REVISED RESPONSE TO REQUEST FOR ADDITIONAL INFORMATION

APR1400 Design Certification

Docket No. 52-046

RAI No.: 253-8300
SRP Section: 03.07.01 – Seismic Design Parameters
Application Section: 3.7.1
Date of RAI Issue: 10/19/2015

Figure 3.7A-12 Comparison of Design Time History Compatible with CSDRS with Site Response Motion at Foundation Base Elevation of Seismic Category I Structures, E-W Motion, 5% damping

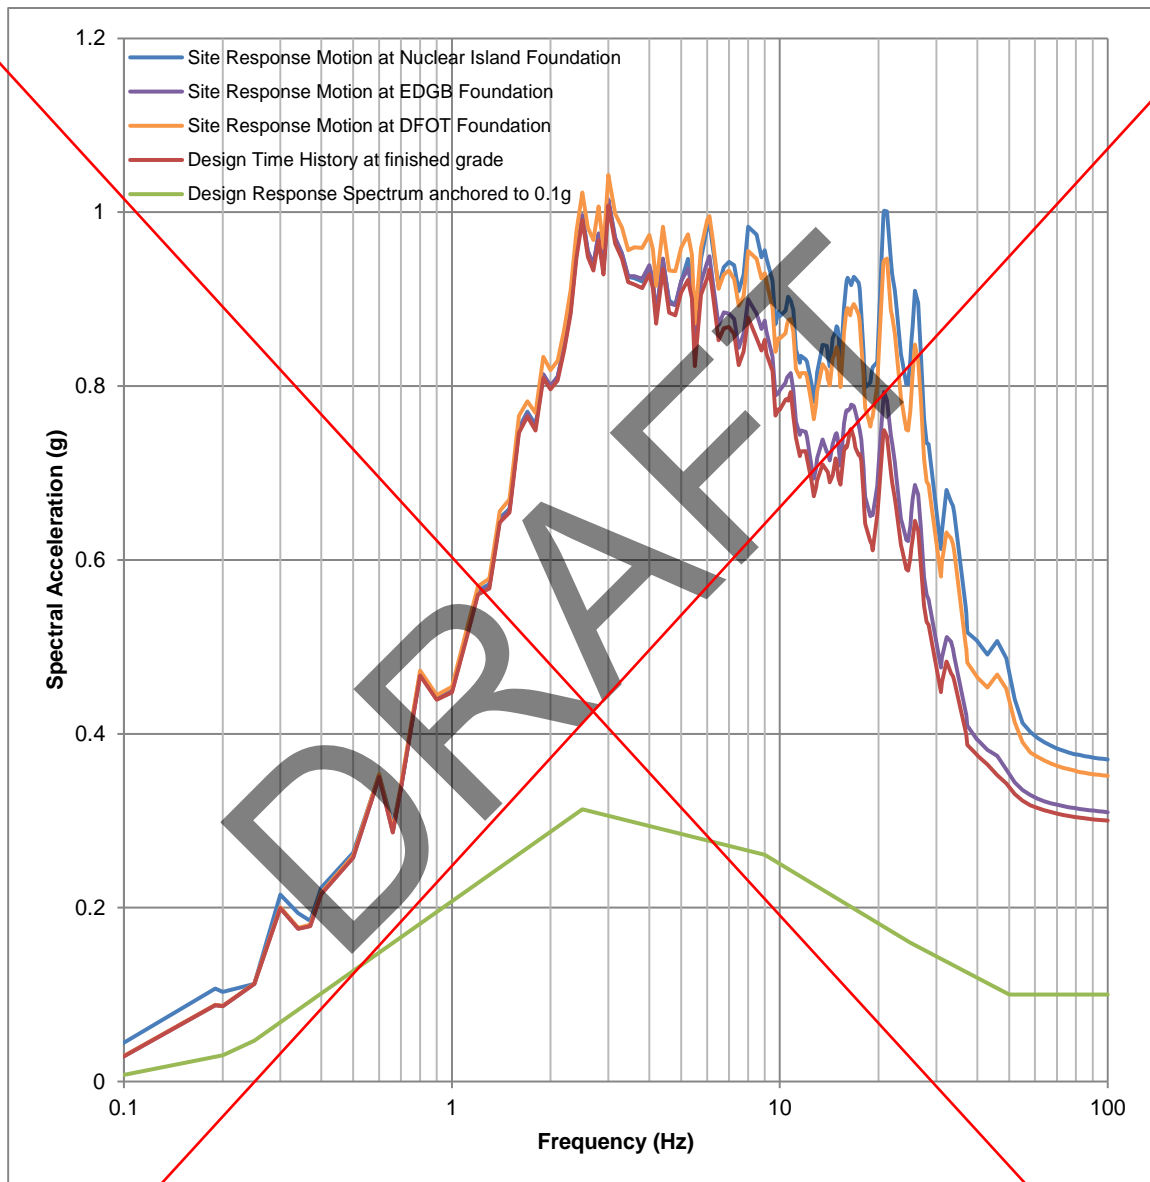
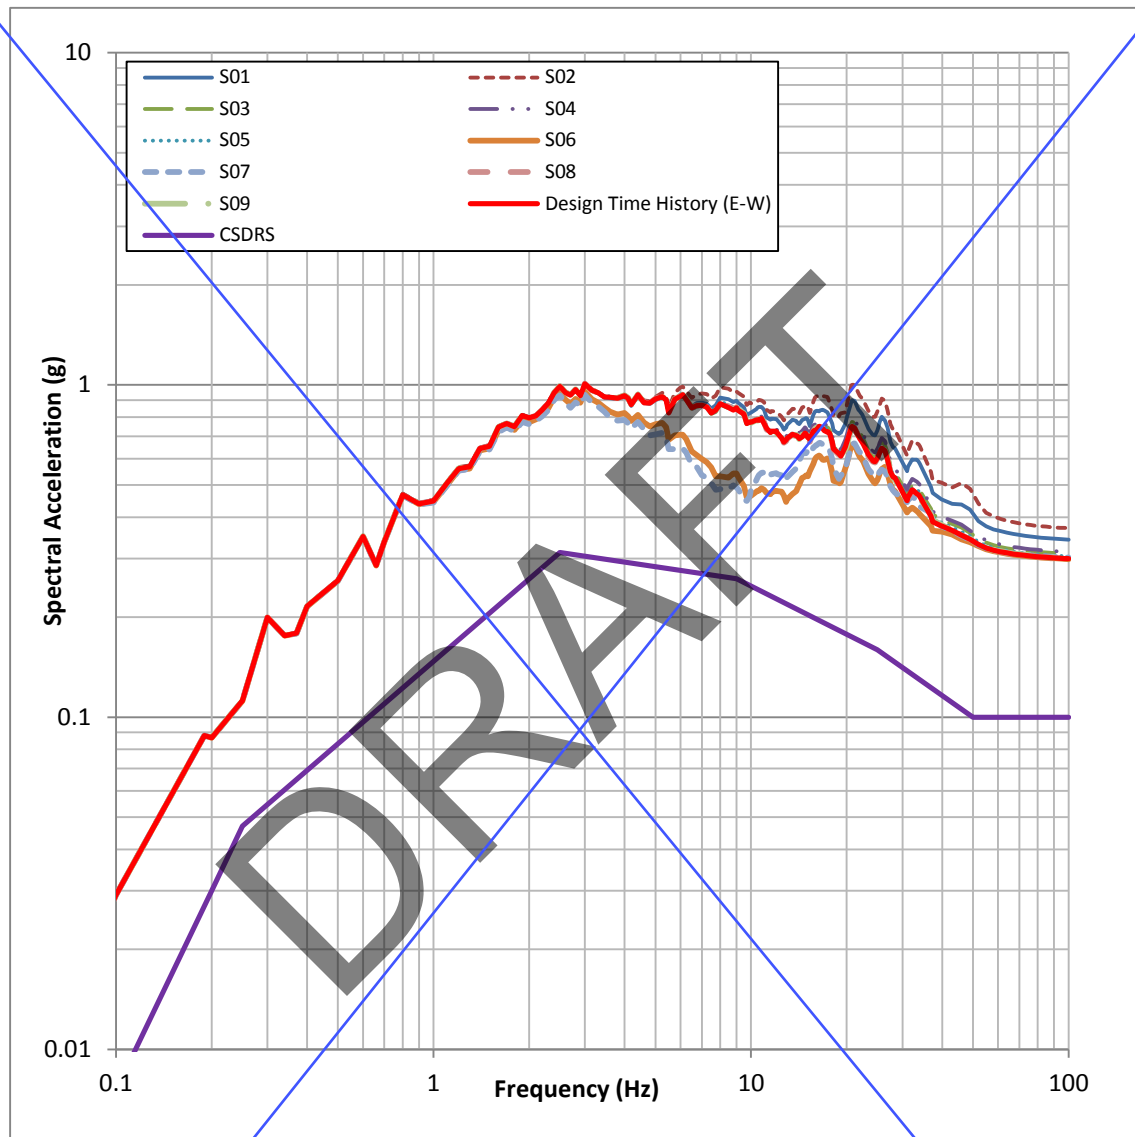
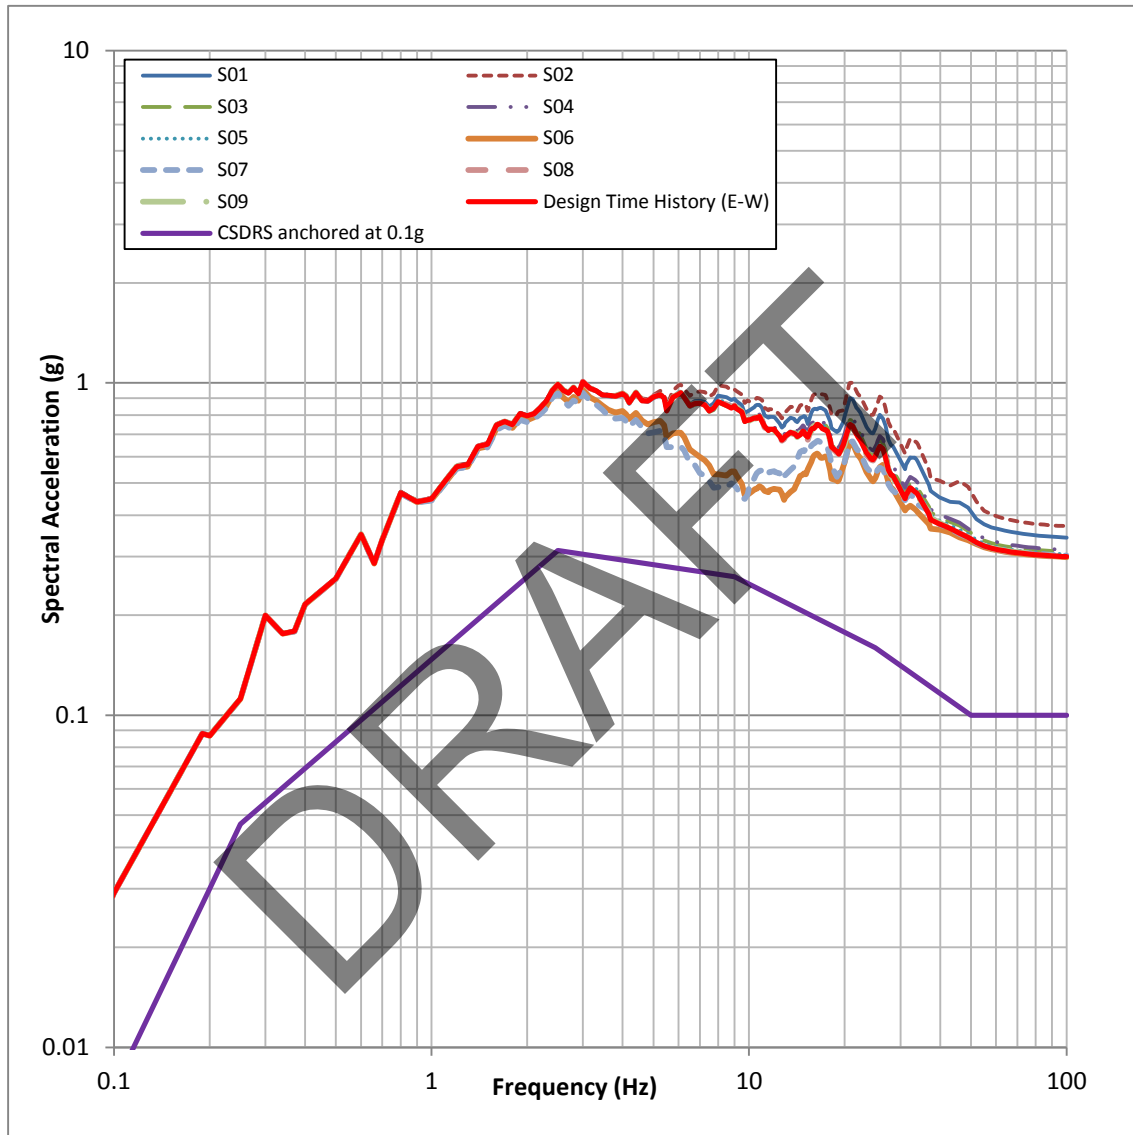
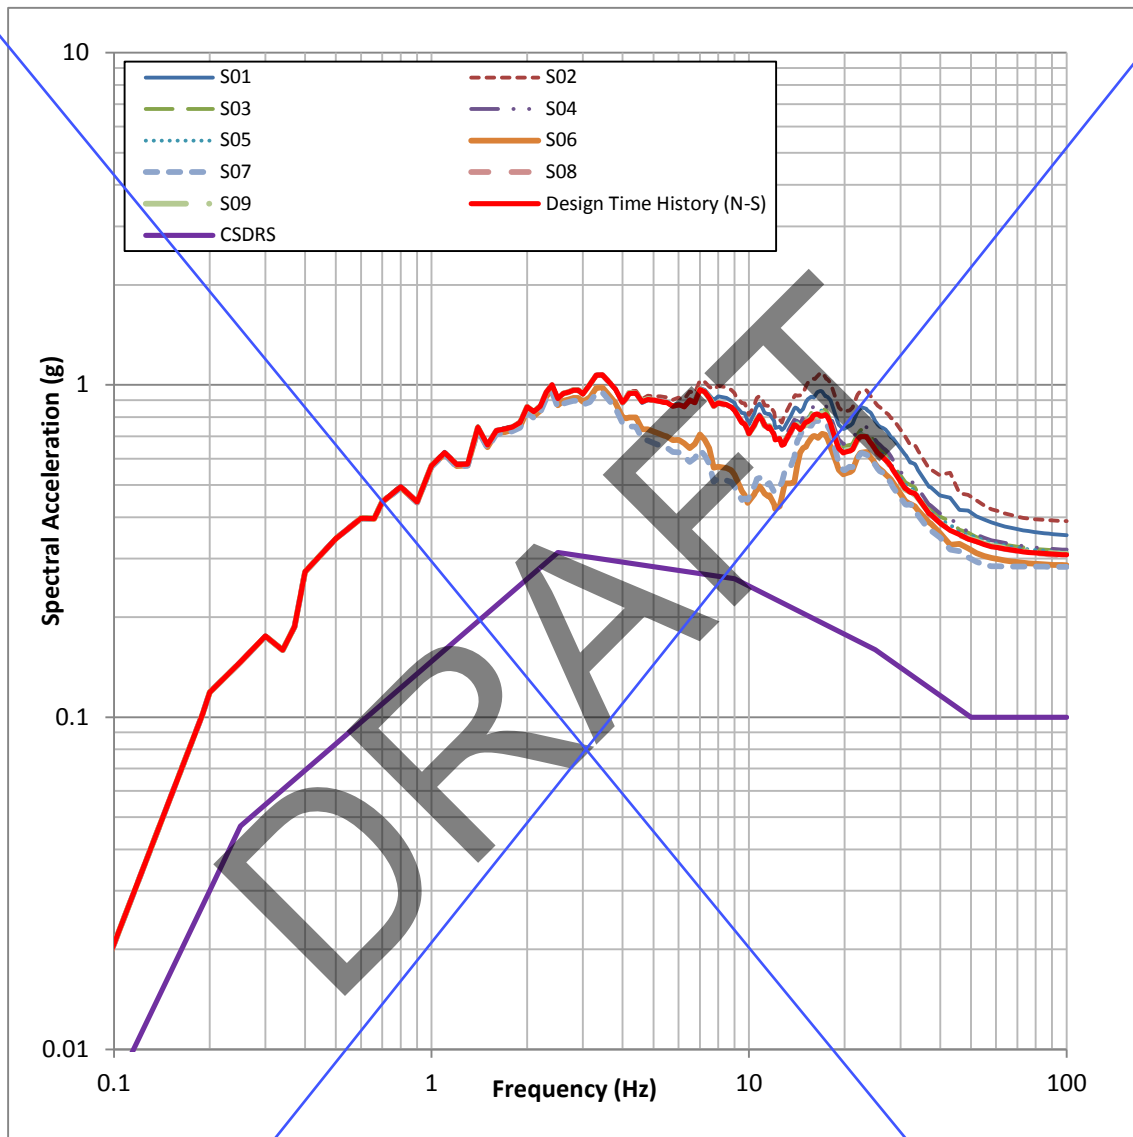
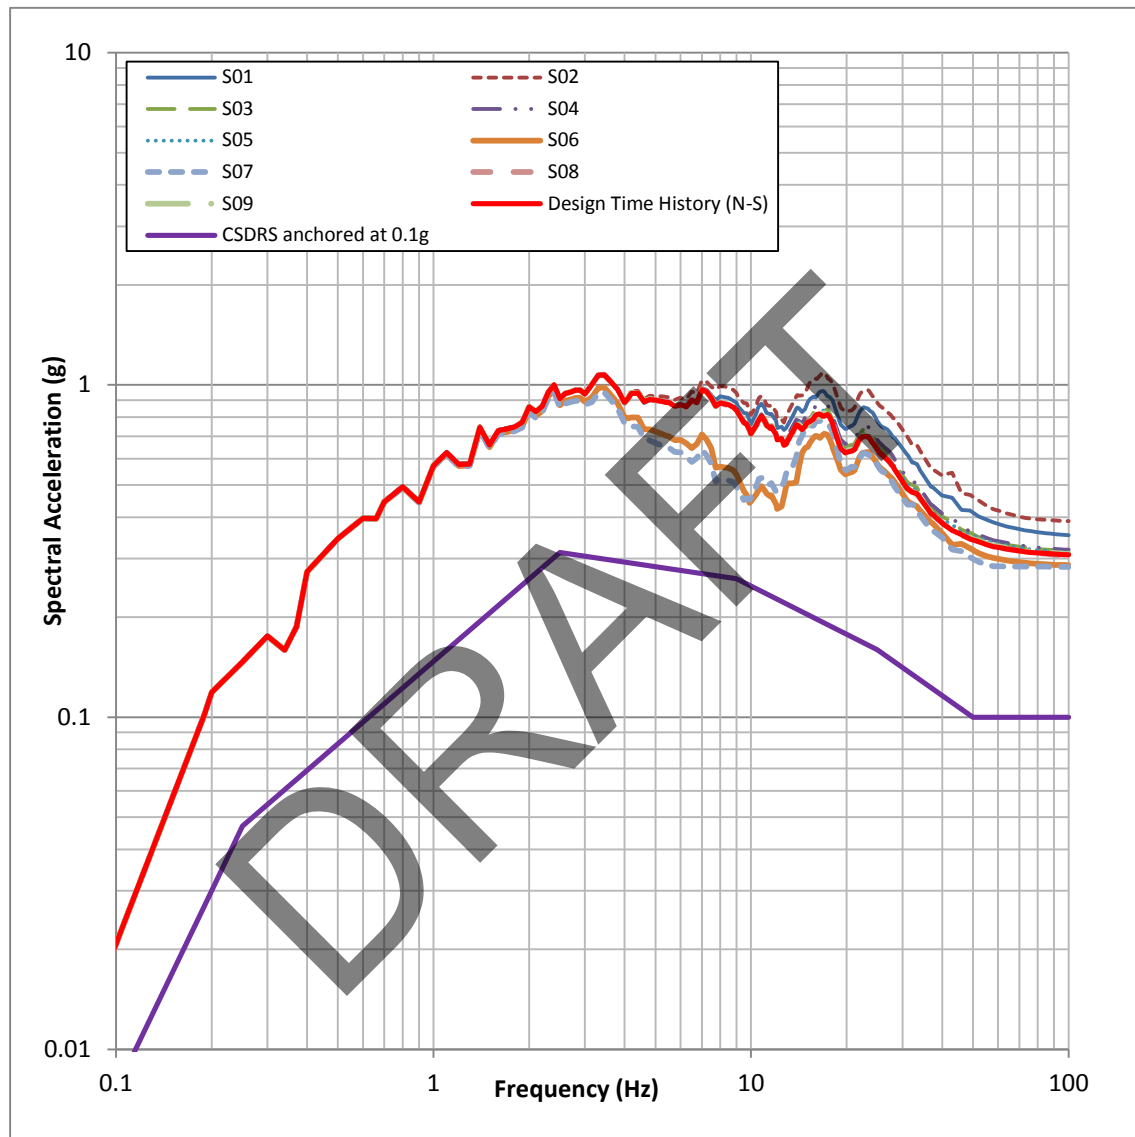
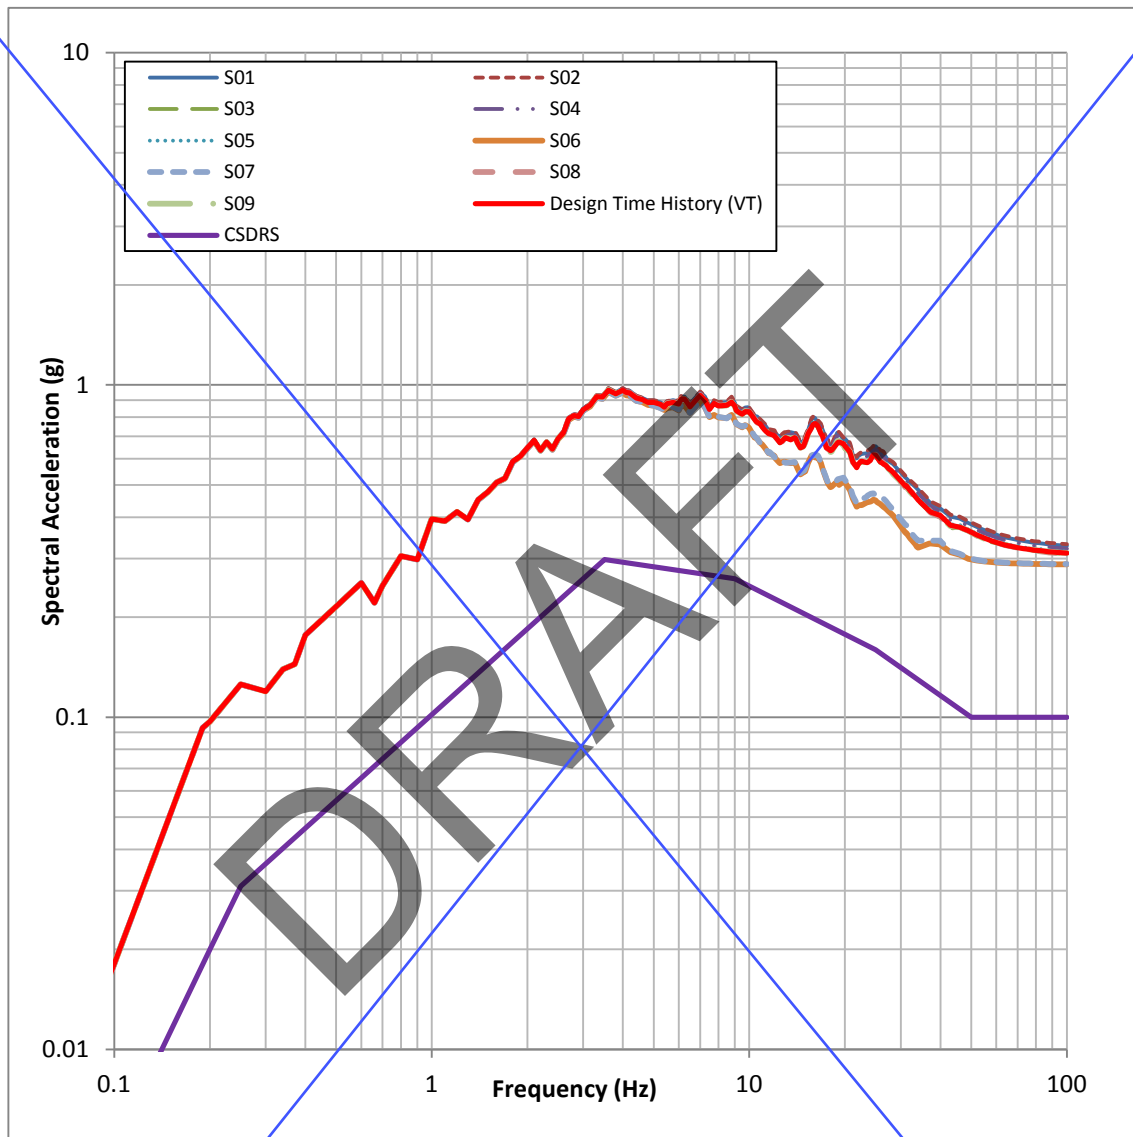
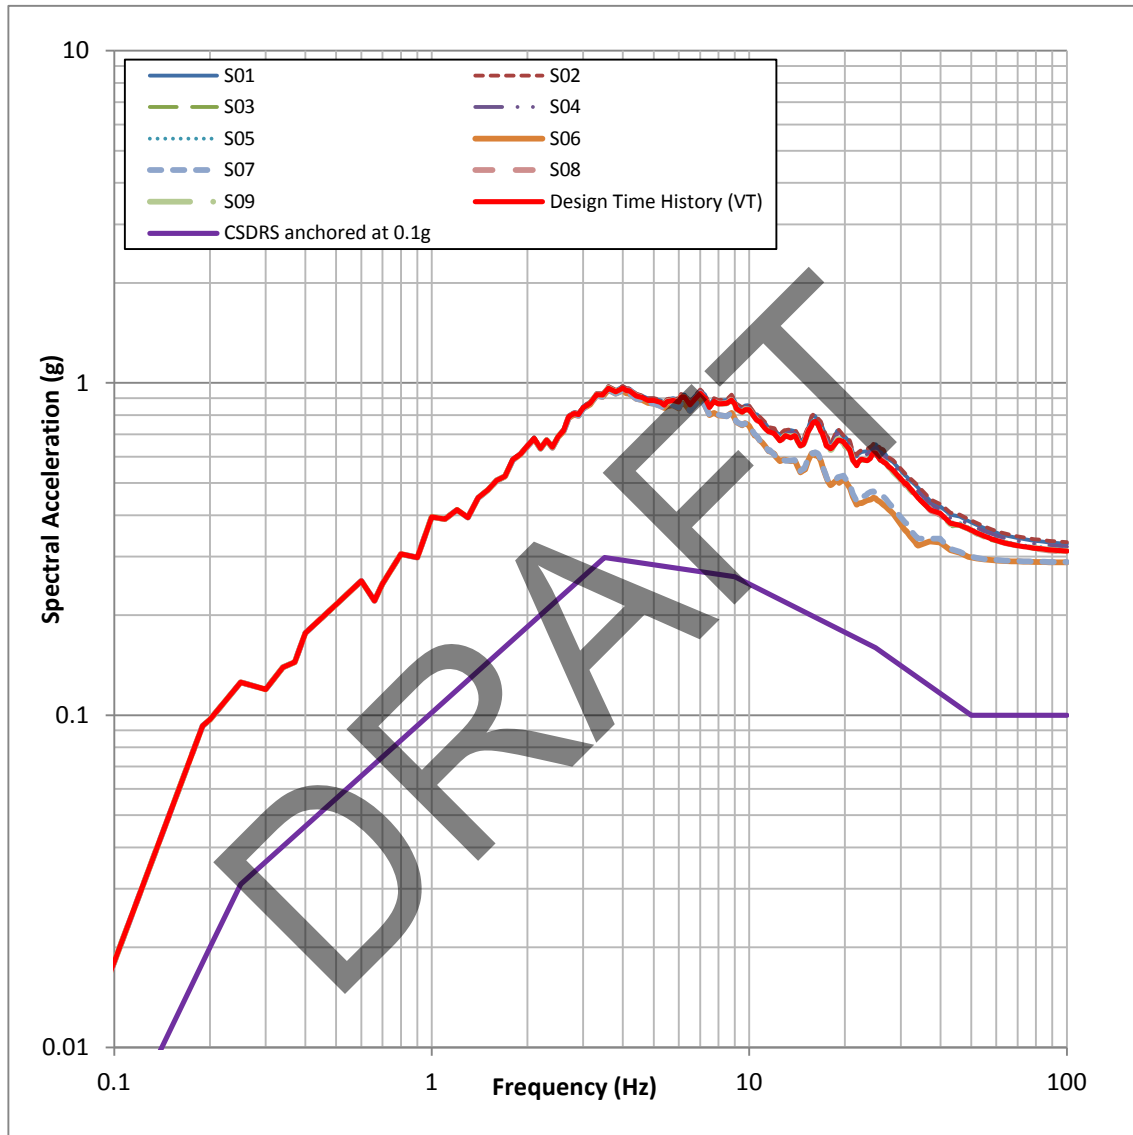
i) Since each of the nine soil profiles can potentially be a valid COL site, these generic soil profiles should be assessed separately when comparing to the Appendix S 0.1g requirement. The use of the envelope, as shown in Figures 3.7A-12 and 3.7A-23, is not sufficient to show that all soil cases satisfy Appendix S. The staff notes that individual CSDRS_{ff} are available in APR1400-E-S-NR-14001-P, Rev. 0; however, this technical report is not incorporated by reference (IBR) in the DCD, and the figures in the report do not show a direct comparison to an appropriate response spectrum with a peak ground acceleration of at least 0.1g. Therefore, the applicant is requested to supplement Figures 3.7A-12 and 3.7A-13, to show that each of the 9 CSDRS_{ff} for the NI, EDGB, and DFOT structures satisfies the Appendix S 0.1g requirement.

ii) The CSDRS are defined in DCD Section 3.7.1.1.1 as linearly interpolated on a log-log scale between the control points. The CSDRS scaled to 0.1g in Figures 3.7A-12, 3.7A-13, and 3.7A-14 are not correct because they are interpolated on a log-linear scale. Therefore, the CSDRS scaled to 0.1g should be corrected in Figures 3.7A-12 through 3.7A-14 of the DCD.

iii) Some of the labels in Figures 3.7A-12 and 3.7A-13 do not appear to be in the correct order. For example, labels for EDGB and DFOT appear to be switched in Figure 3.7A-12, and the labels for NI, EDGB, and DFOT seemingly should be EDGB, DFOT, and NI, respectively, in Figure 3.7A-13 (based on comparison to Figures 5-25 through 5-31 in APR1400-E-S-NR-14001-P, Rev. 0). In this report, Figure 5-26 appears to be exactly the same as Figure 5-25. The applicant is requested to correct these incorrect labels and figures in the DCD and report.

- a) Figures 3.7A-12, 3.7A-13, and 3.7A-14 in DCD Tier 2 and Figures 5-25 through 5-31 in APR1400-E-S-NR-14001-P/NP, Rev.0, "Seismic Design Bases" will be revised as indicated in the attachment associated with this response. The revised figures are presented on a log-log scale. Labels on the revised figures, along with those which have not been changed in the DCD and technical reports, have been reviewed and confirmed to be correct. DCD Tier 2, Section 3.7.6 cites ARP1400-E-S-NR-14001-P/NP, Rev.0, "Seismic Design Bases" as Reference 9.
- b) The $CSDRS_{ff}$ is generated from outcrop motions using the SHAKE91 program. The outcrop motions are calculated at the foundation elevation of each building. The procedure described in the NEI white paper, "Consistent Site-Response/Soil-Structure Interaction Analysis and Evaluation," (June 12, 2009) was followed to produce the results.
